49 CFR Part 572

[Docket No. 2008–0111]

Anthropomorphic Test Devices; ES–2re Side Impact Crash Test Dummy 50th Percentile Adult Male

ACTION: Final rule, response to petitions for reconsideration, technical amendment.

FIGURE 1: FULL BODY THORAX IMPACT TEST RESULTS FOR UPPER RIB DEFLECTION

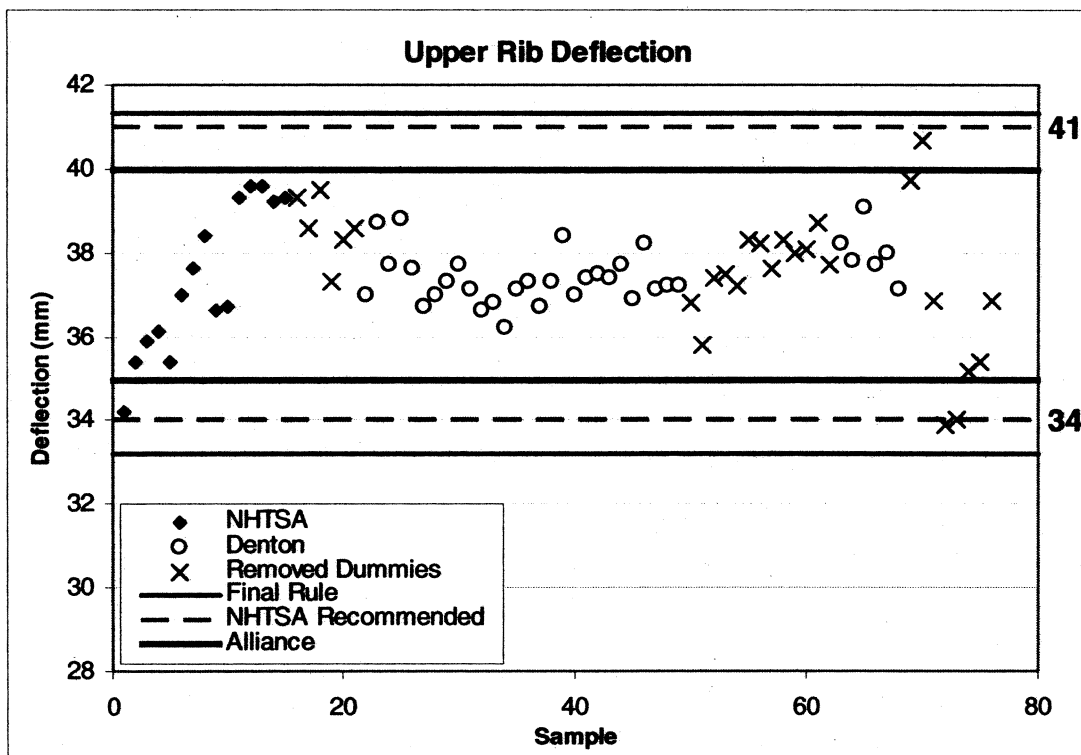
All of the data in the complete dataset (i.e., without any dummies removed) fit within the specified final rule corridor of 33.2–41.3 mm, as seen in Figure 1 below. The Alliance petitioned to narrow the corridor bounds to a range of 35–40 mm. The data set with the

indicated dummy responses removed (“revised data set”) has a mean deflection of 37.4 mm, a standard deviation of 1.11 mm and a CV of 2.96 percent. In that this CV is less than 3 percent, we could adopt corridor bounds that are expanded ± 3 standard deviations from the mean,¹⁴ or a range

of 34.1–40.8 mm. When rounded to the next whole numbers away from the mean, this corridor becomes 34–41 mm, which is only slightly narrowed compared to the final rule. This corridor contains nearly all the NHTSA and DTESC data points, and is well-centered about the mean.

FIGURE 2: MIDDLE RIB DEFLECTION RESULTS FROM FULL-BODY THORAX IMPACT TESTS

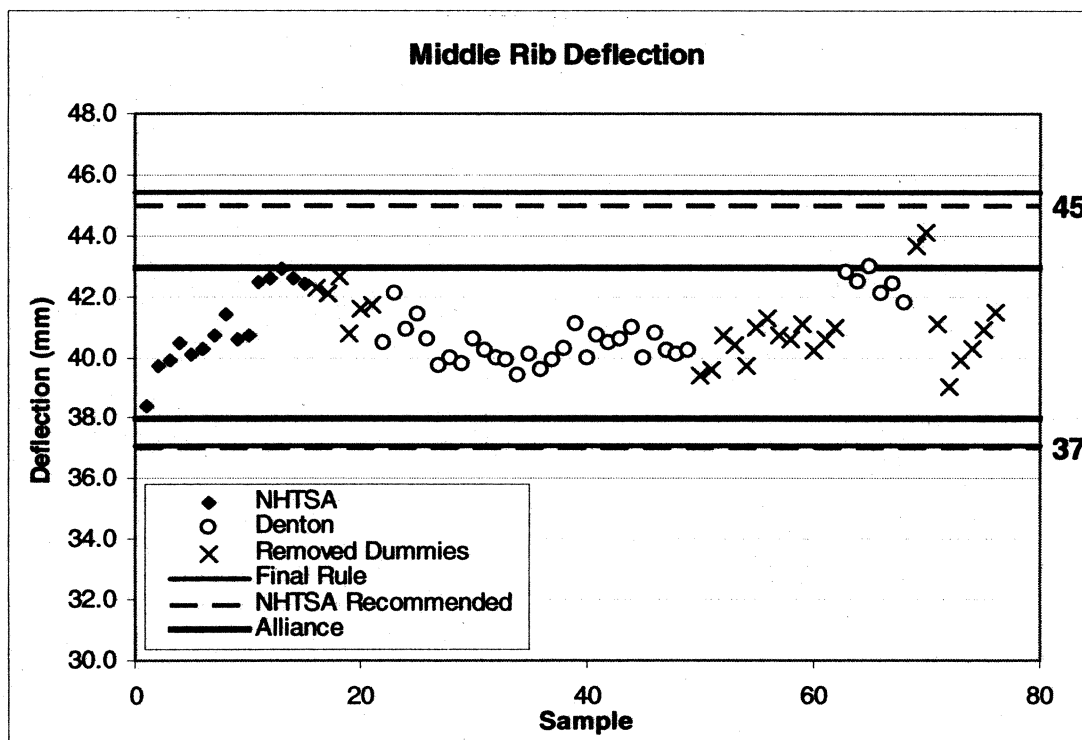
All data in the complete DTESC data set also fit within the corridors specified in the final rule for middle rib deflection, 37.1–45.4 mm (see Figure 2 below). However, the Alliance petitioned for narrowed corridor bounds

of 38–43 mm. Statistical analysis of the revised data set resulted in a mean response of 40.8 mm, a standard deviation of 1.09 mm and a CV of 2.67 percent. This CV allows for corridor bounds placed at ± 3 standard deviations from the mean, or a range of 37.6–44.1 mm (37–45 mm when rounded away

FIGURE 3: LOWER RIB DEFLECTION RESULTS FROM FULL BODY THORAX IMPACTS

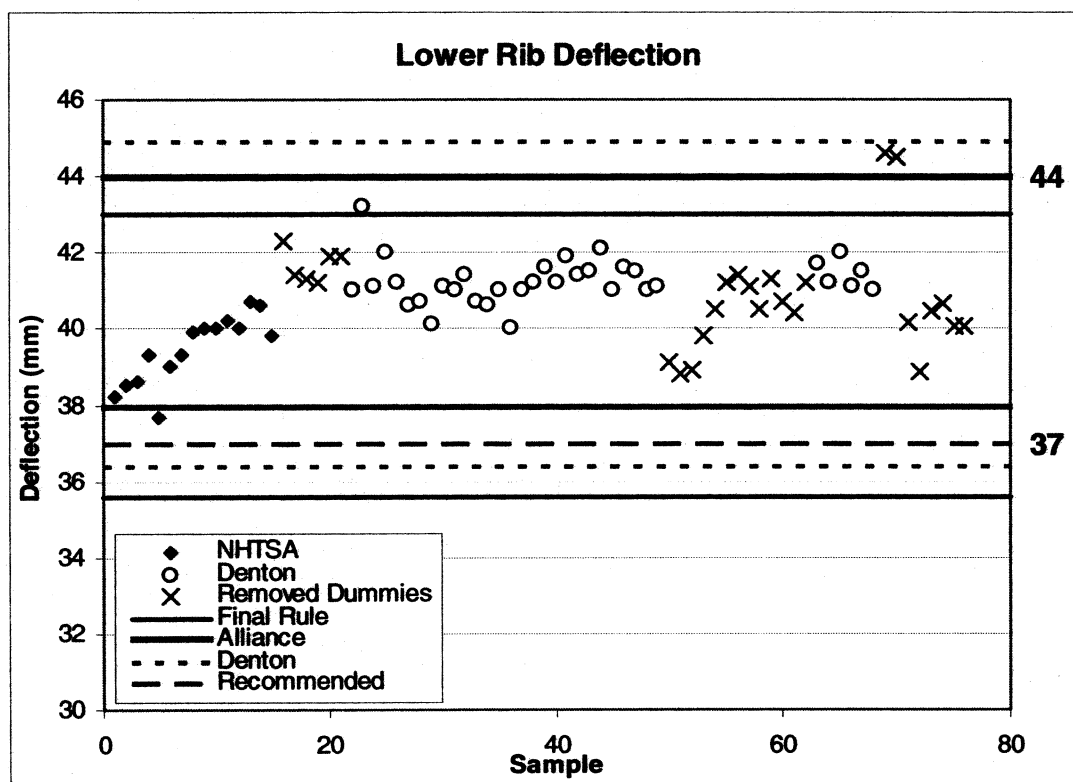
Denton and GM dummies in the DTESC-compiled data set submitted in Denton's petition for reconsideration show deflections that are generally higher than those measured by NHTSA. The final rule specified a range of 35.6–43.0 mm, while the Alliance and Denton recommended corridors ranging from 38–44 mm and 36.4–44.9 mm,

respectively. Based on statistical analysis of the revised DTESC data set, an adjustment of the corridor bounds to reflect these higher responses from a larger population of dummies is appropriate. The revised data set has a mean response of 40.7 mm, a standard deviation of 1.08 mm, and a CV of 2.66 percent. This CV allows for expansion of the bounds ± 3 standard deviations

from the mean, producing a range of 37.5–43.9 mm, or 37–44 mm when rounded away from the mean. This corridor is slightly smaller than and shifted upward from the final rule corridor, but wider than the corridor for which the Alliance petitioned. This corridor contains nearly all petitioner-submitted data as well as all NHTSA data (Figure 3).

FIGURE 4: TEST RESULTS FOR THE “PEAK IMPACTOR FORCE AFTER 6 MS” MEASUREMENT AS COLLECTED BY NHTSA, DENTON, GM AND FTSS

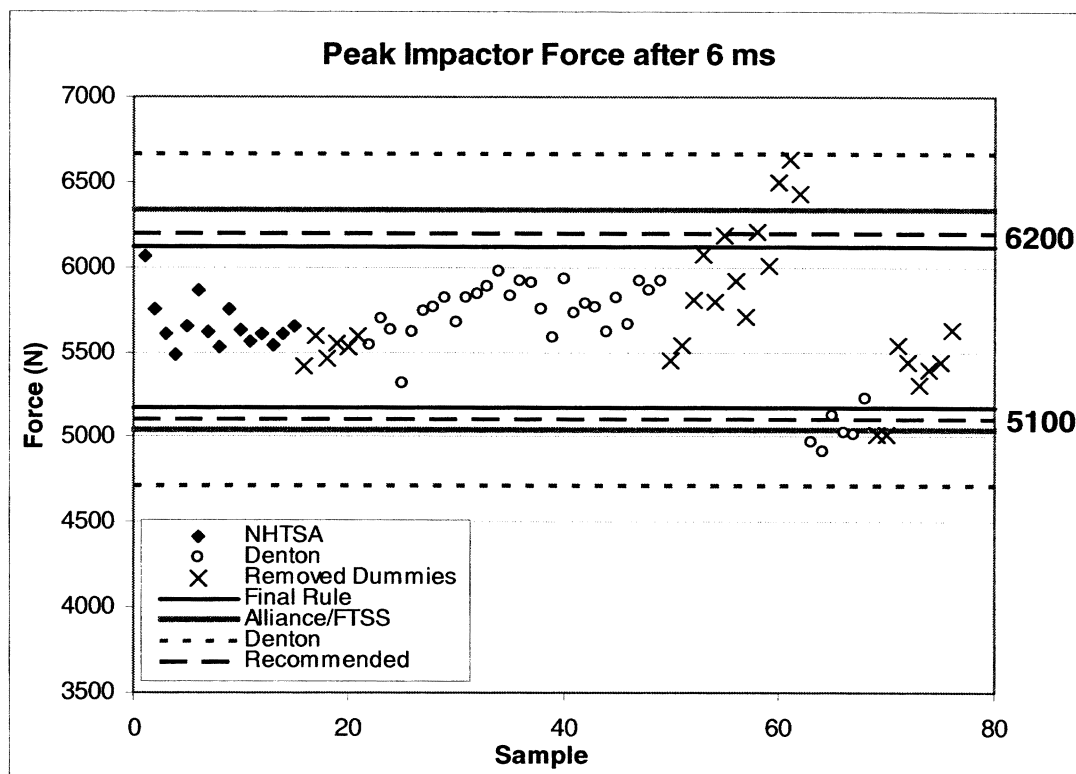
The additional peak impactor force data compiled by the SAE DTESC and submitted by Denton provide additional points with which to form statistically-based corridors. In its petition, the Alliance used this data set to propose a corridor of 5045–6344 N, while Denton recommended a range of 4720–6669 N,

as shown in Figure 4. FTSS recommended a performance corridor of 5039–6159 N for this measure. (The FTSS corridor is close to the Alliance recommendation, therefore to avoid clutter in Figure 4, it is shown to correspond to the Alliance corridor.) The mean response derived from the revised data set was 5643 N, with a SD

of 268 N and a CV of 4.76 percent. This CV allows for setting the corridor limits at ± 2 standard deviations from the mean, at 5107–6180 N. Rounded away from the mean, the lower and upper corridor bounds of the recommended corridor are 5100 N and 6200 N, respectively, a range very close to that which was petitioned by FTSS.

Figure U2-A
NECK/LUMBAR SPINE/HEADFORM ATTACHED TO PENDULUM

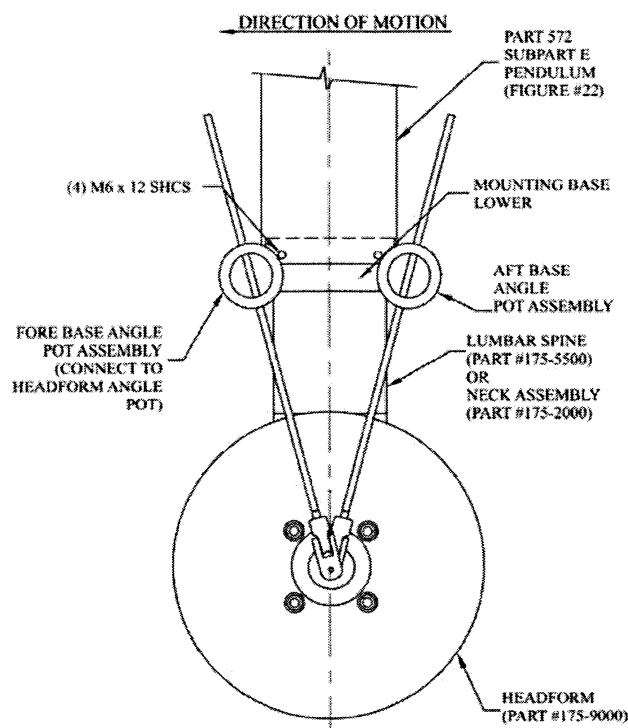
11. The agency has found an error in Figure U2-A, which specifies the pendulum for neck/lumbar spine qualification tests to be the "Part 572 Subpart E Pendulum (Figure #15)". The description and figure number do not refer to the same pendulum. This document makes a technical amendment by correcting the reference to read, "Part 572 Subpart E Pendulum (Figure #22)".

■ 8. Figure U2-A in “APPENDIX A TO SUBPART U OF PART 572—FIGURES” is revised to read as follows:
